Addendum 2

Project Stadium New Press Box – Marlin ISD
Issued December 8, 2023 by CEI Engineering Associates, Inc.
Proposal Opening December 14th at 2:00 PM

ADDENDUM NO. 2

PROJECT: Marlin ISD - Pressbox
HKS Project No. 26095.000

01 SITE PLAN
1" = 40'-0"

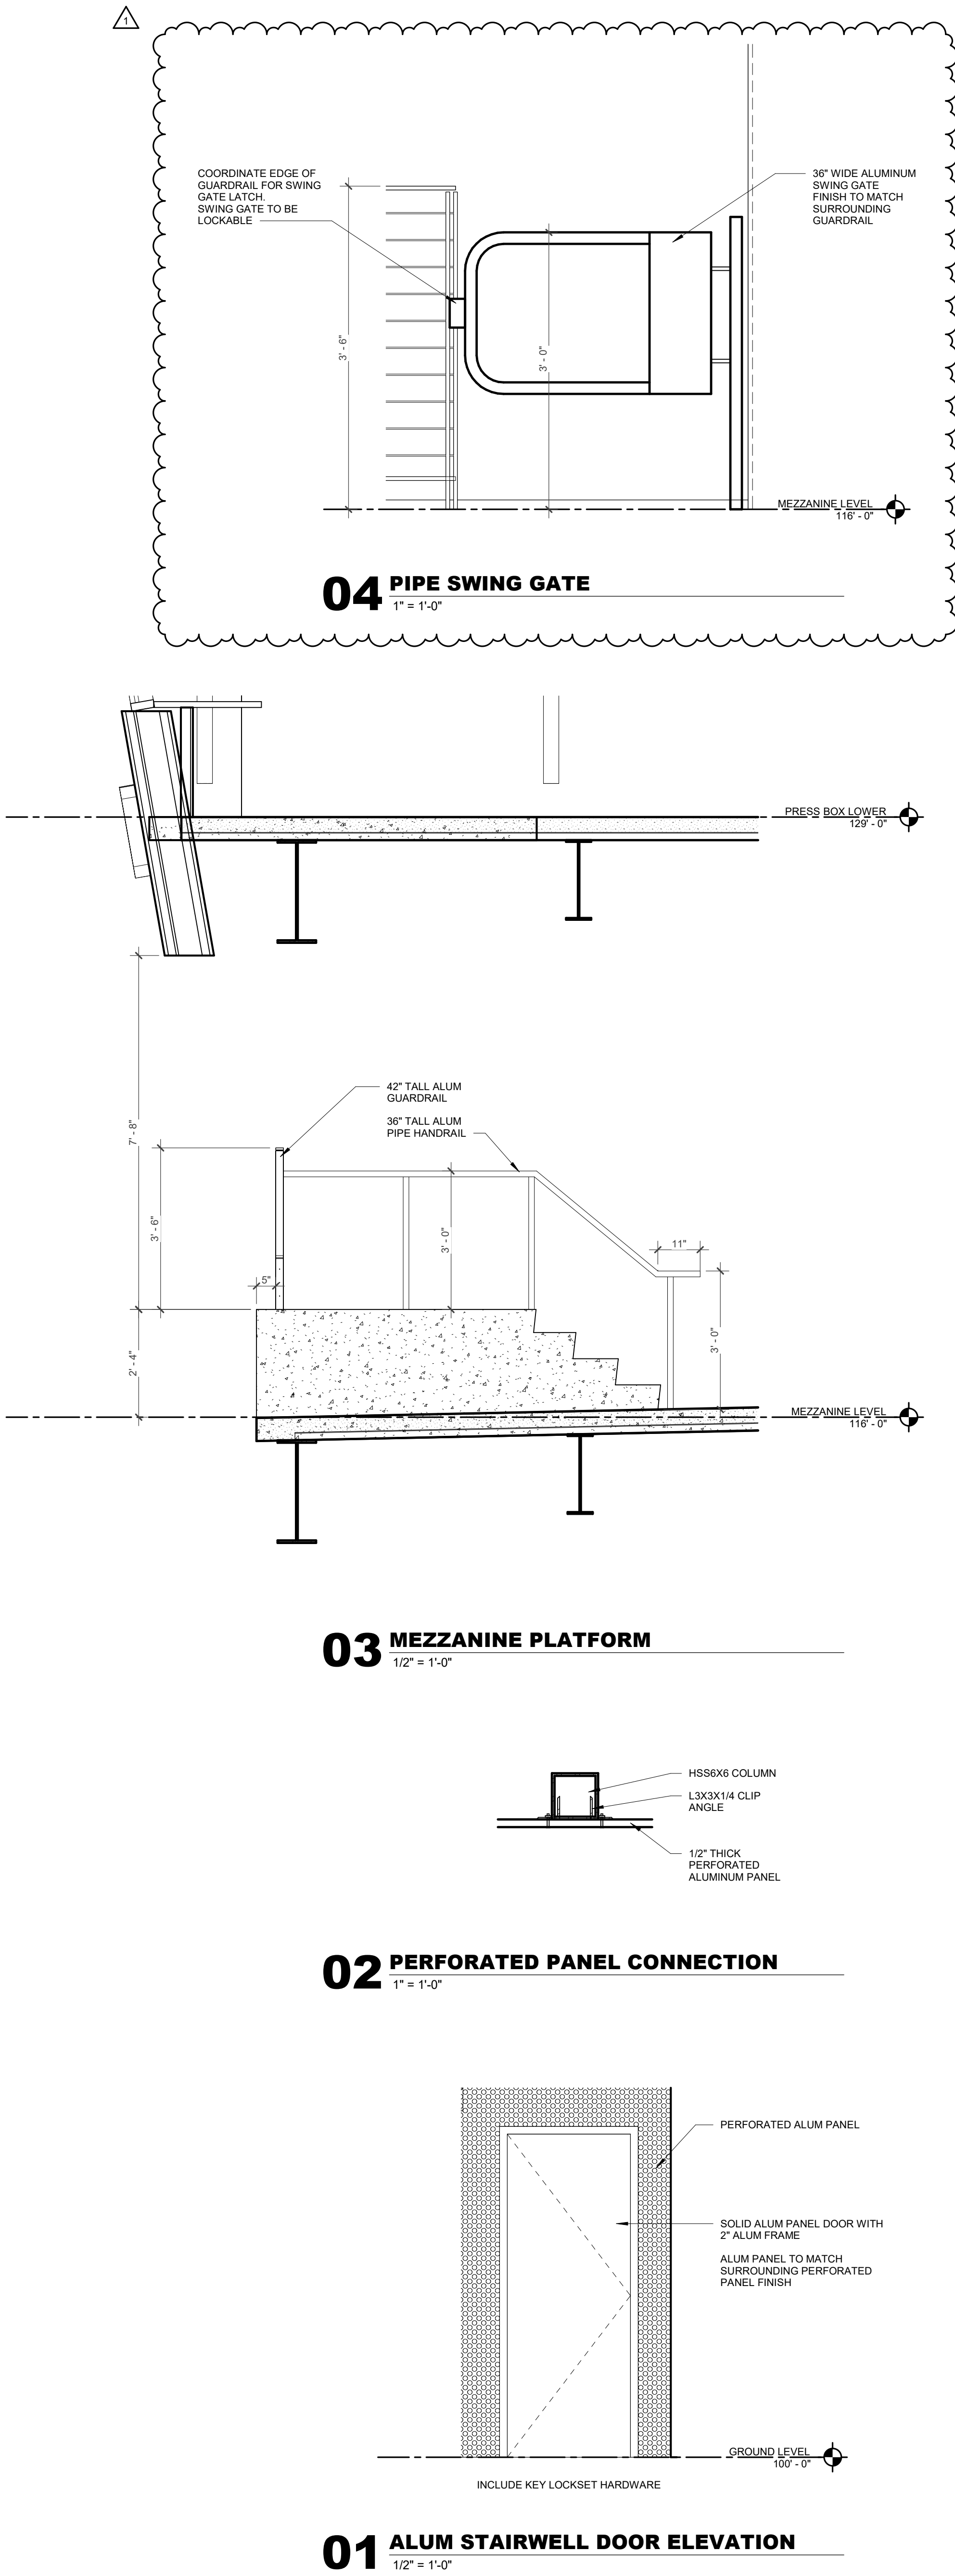
- **A0.01 – PROJECT INFORMATION**
-Updated code and building information
- **A1.00 – SITE PLAN**
-Updated building view range to show ground level
- **A1.01 – SITE DETAILS**
-Added Detail 04 : PIPE SWING GATE

01 ROOF PLAN
1/8" = 1'-0"

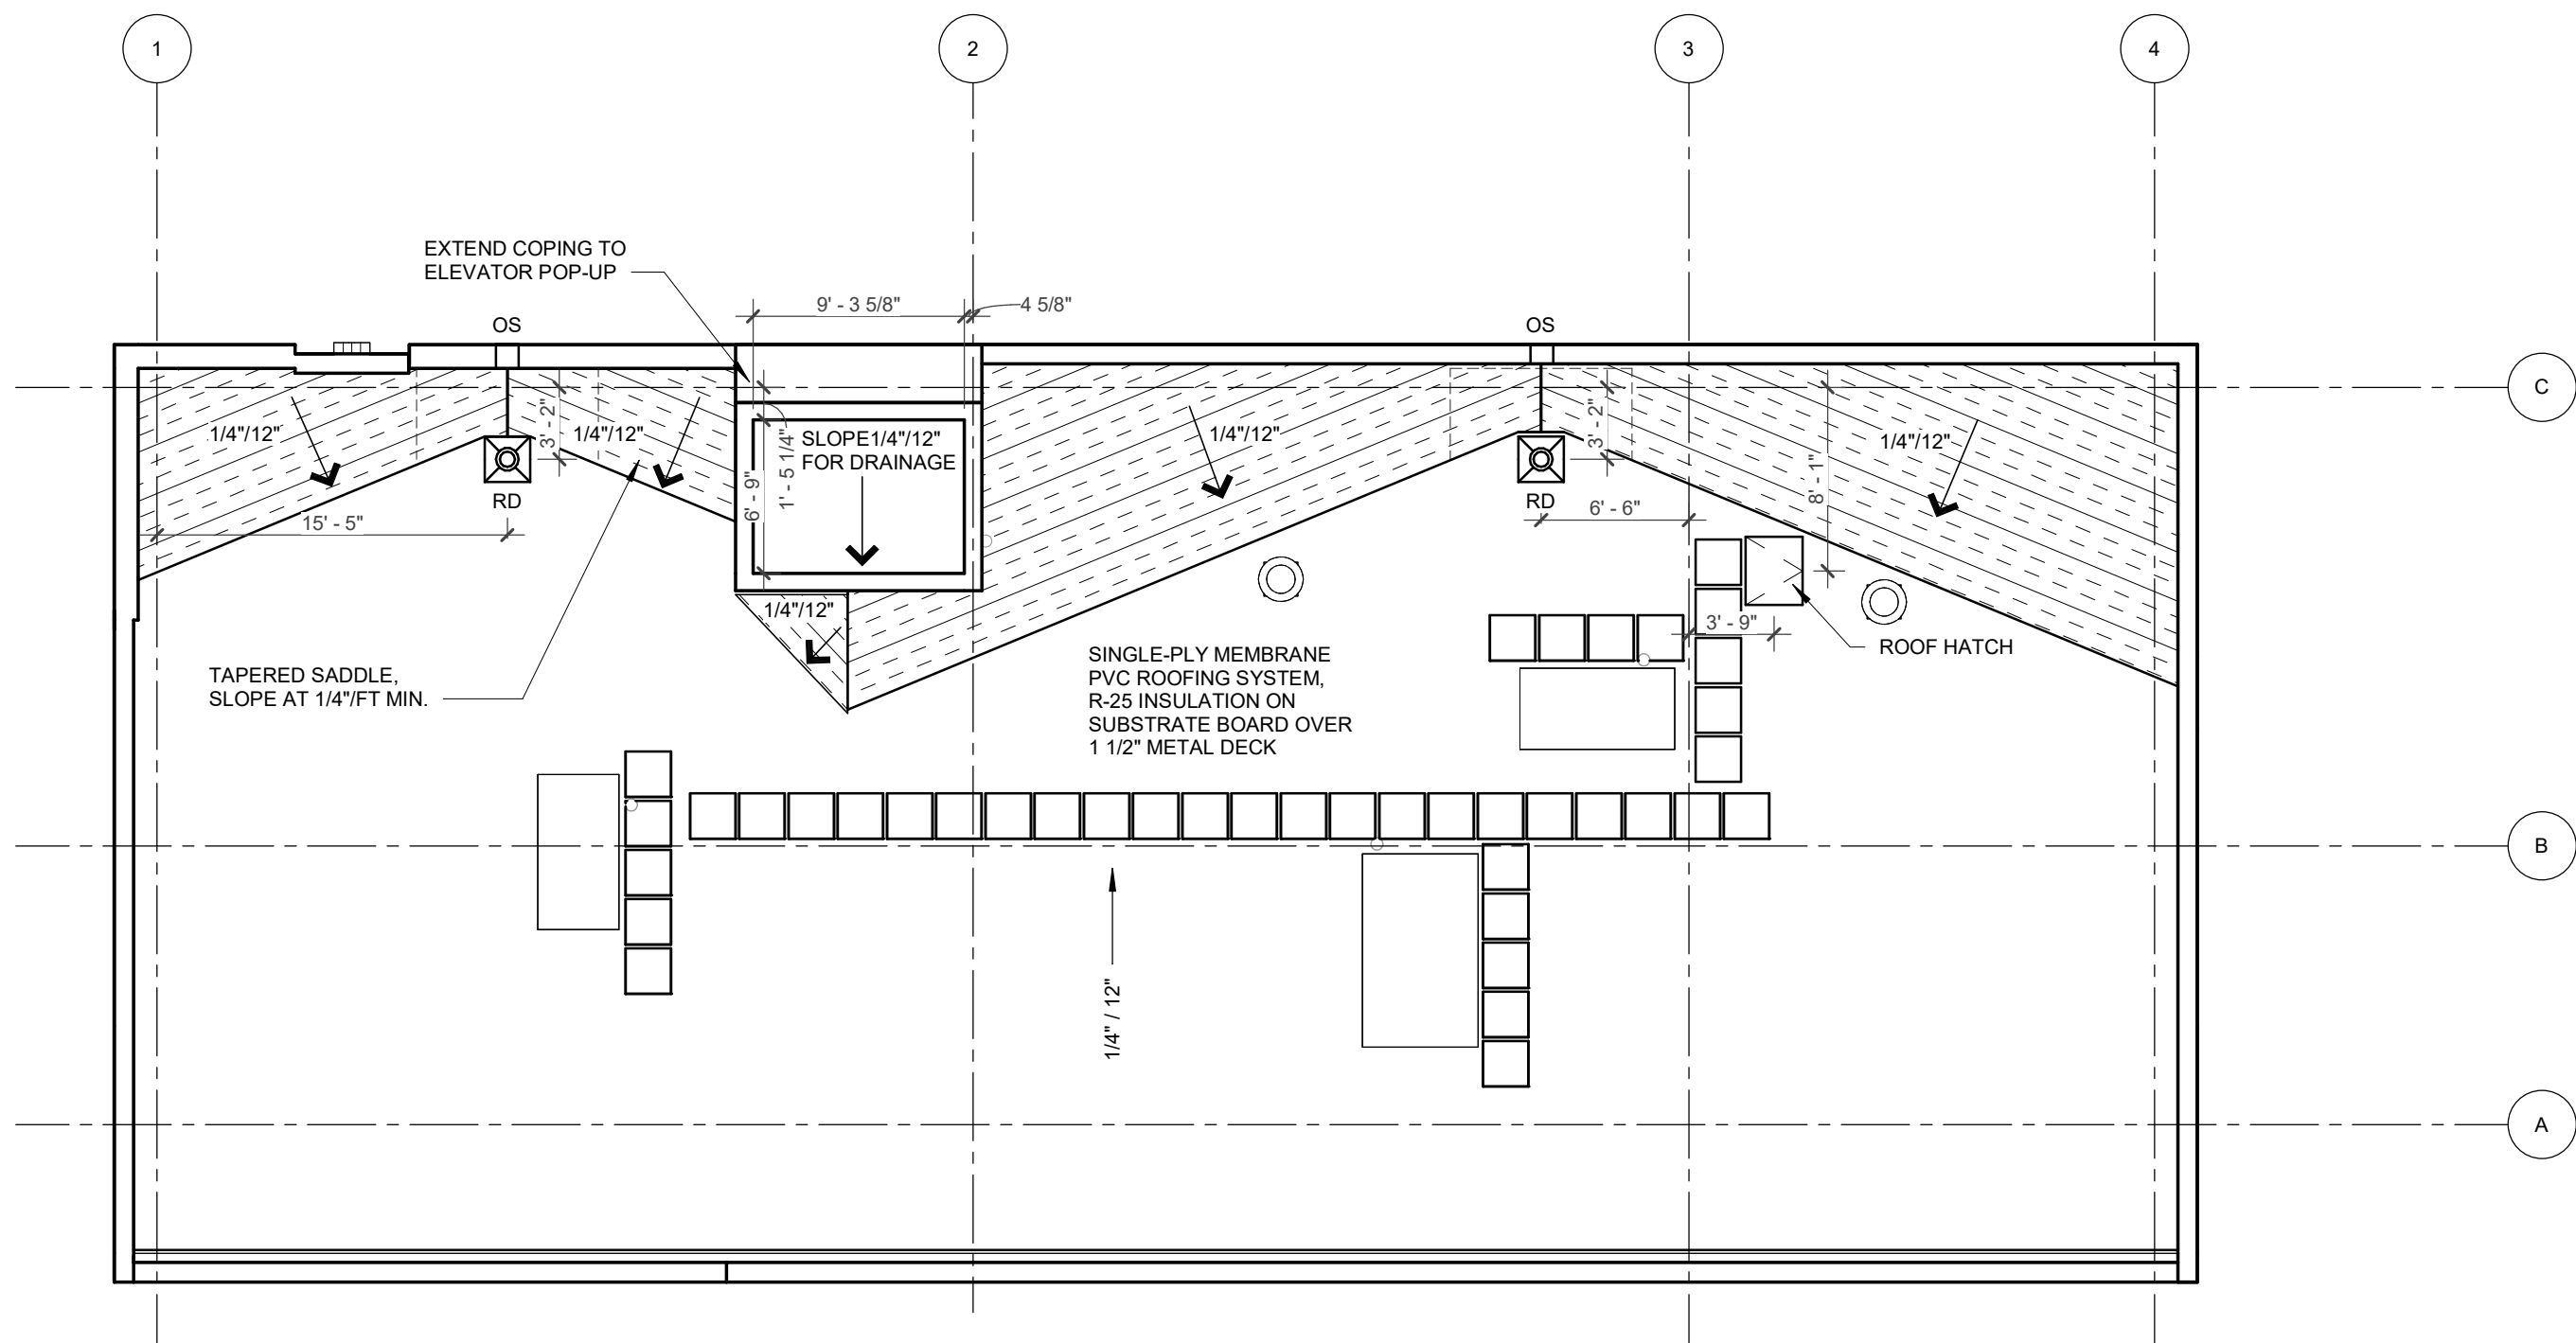
- Combined Storage and IT rooms
 - Increased size of Office appx 1'
 - Relocated roof access ladder on opposite wall in Custodial Room
- **A2.10 – ROOF PLAN**

- Decreased size of elevator pop-up
 - Added coping extension along back of elevator pop-up
 - Adjusted roof hatch location
 - Added walk pads for reference

01 FINISH PLAN - PRESSBOX LEVEL

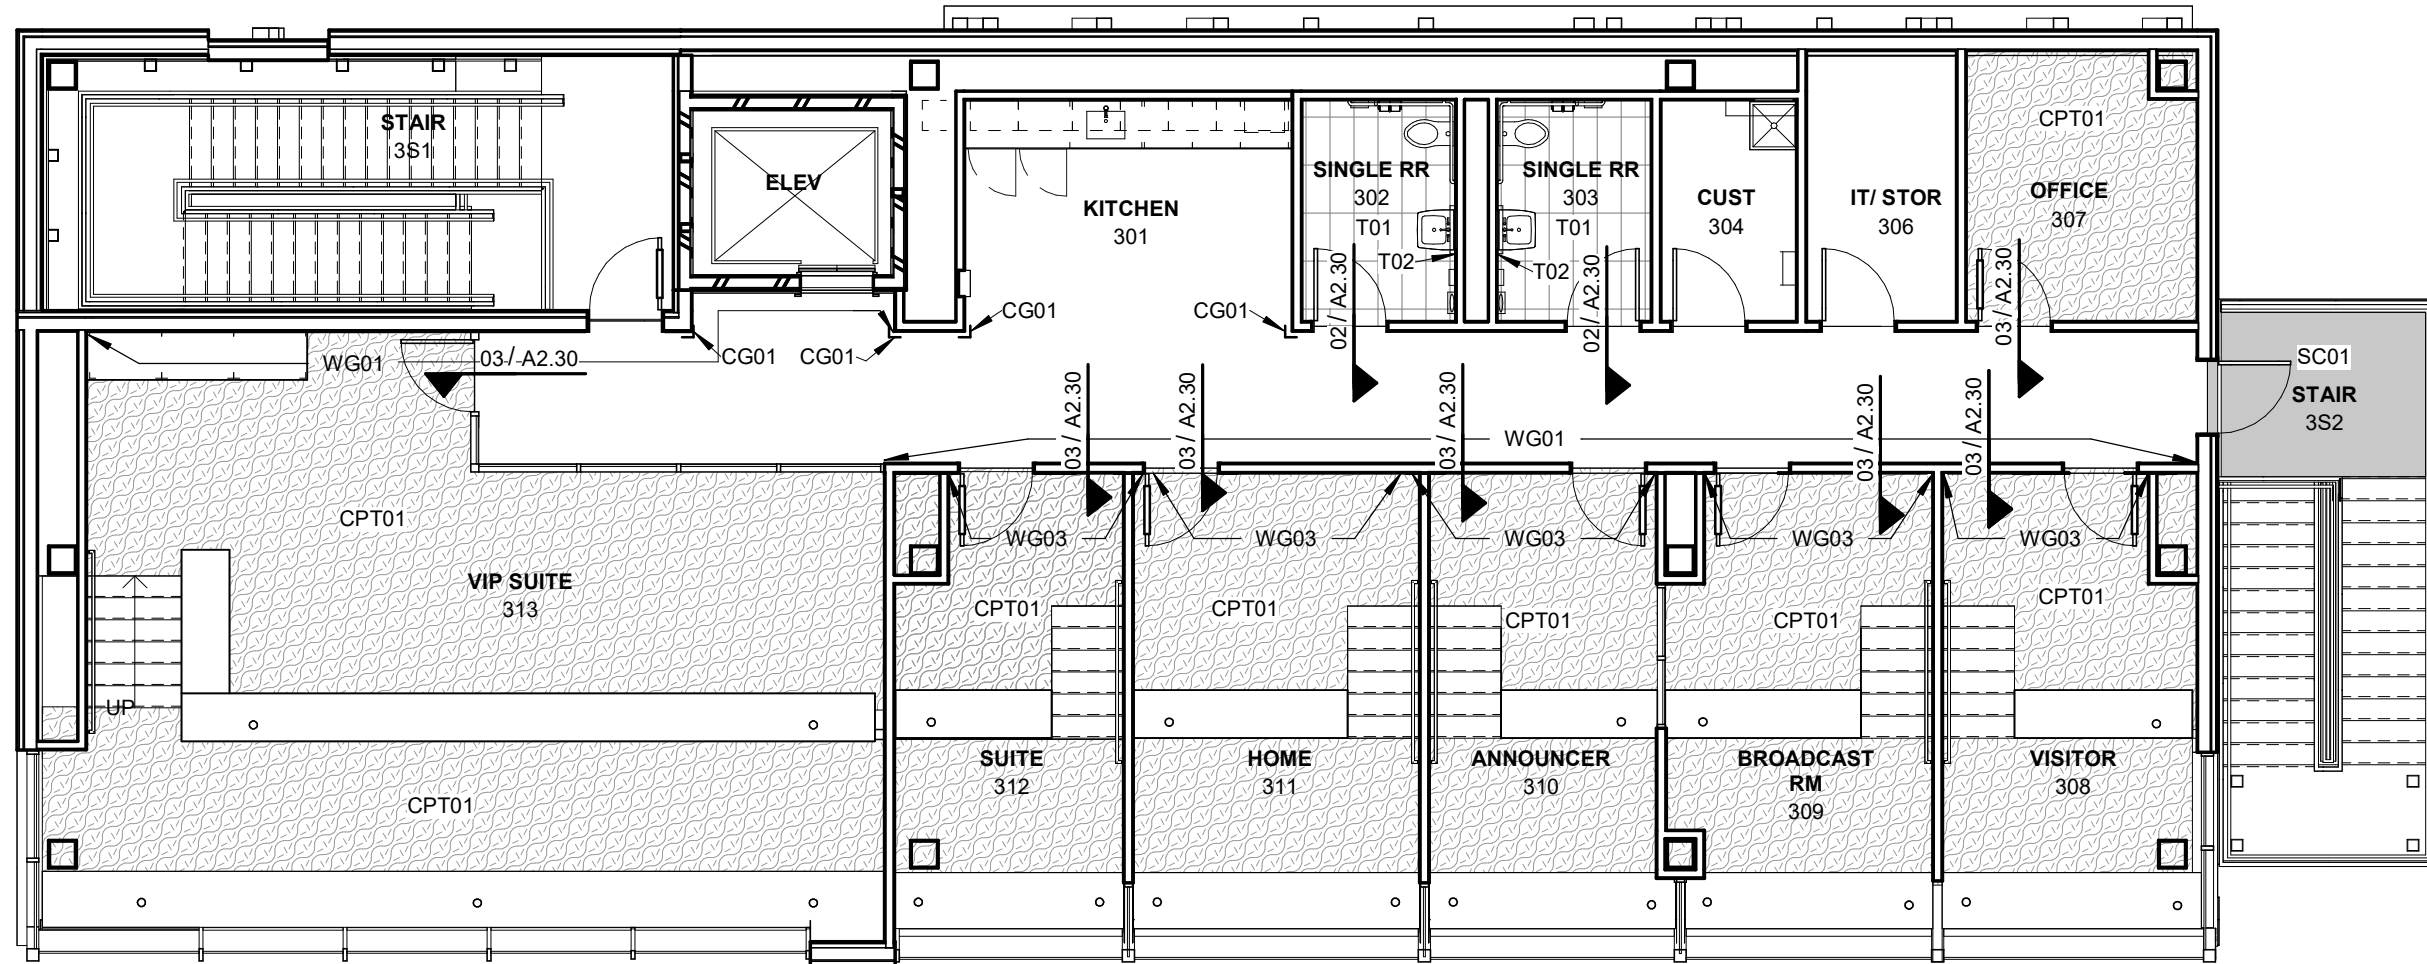
- **A2.30 – FINISH FLOOR PLANS**
 - Changed floor finish to carpet in suites and office
 - Updated Interior Design Selections
- **A3.00 – PARTITION TYPES**

01 301 BATHROOM - EAST
1/4" = 1'-0"

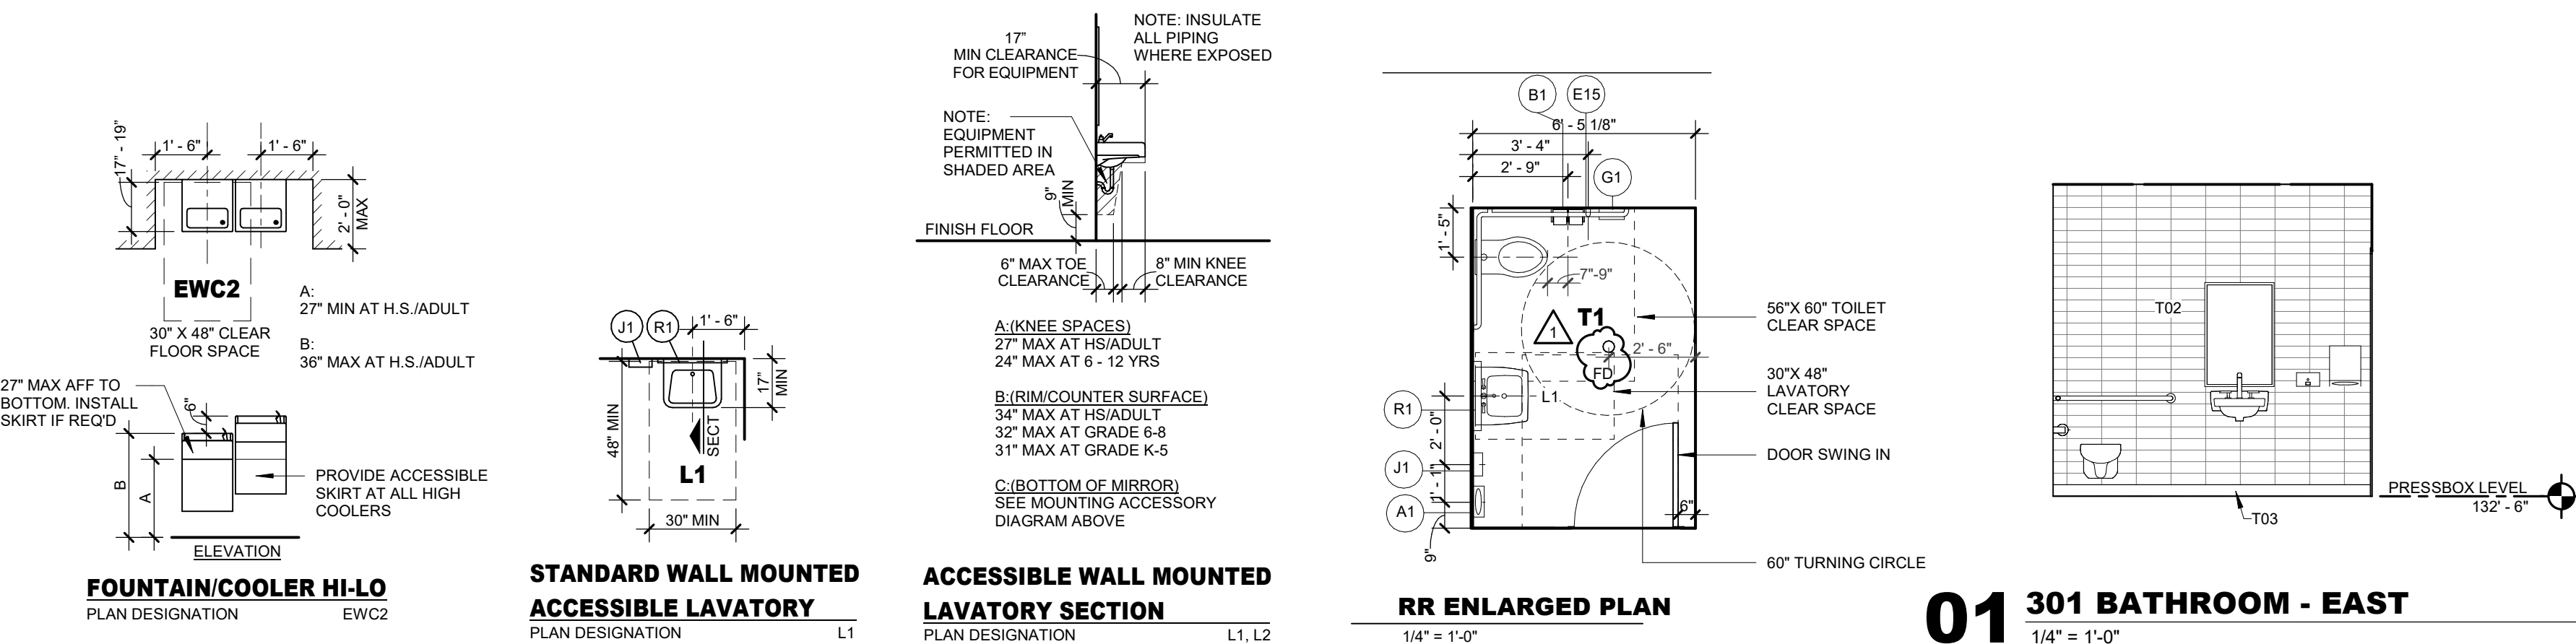
- Updated partition types for Types D, F, and G
- **A3.19 – ADAAG TOILET LAYOUTS AND STD ACCESSORIES - EDUCATION**
 - Added floor drain on RR Enlarged Plan
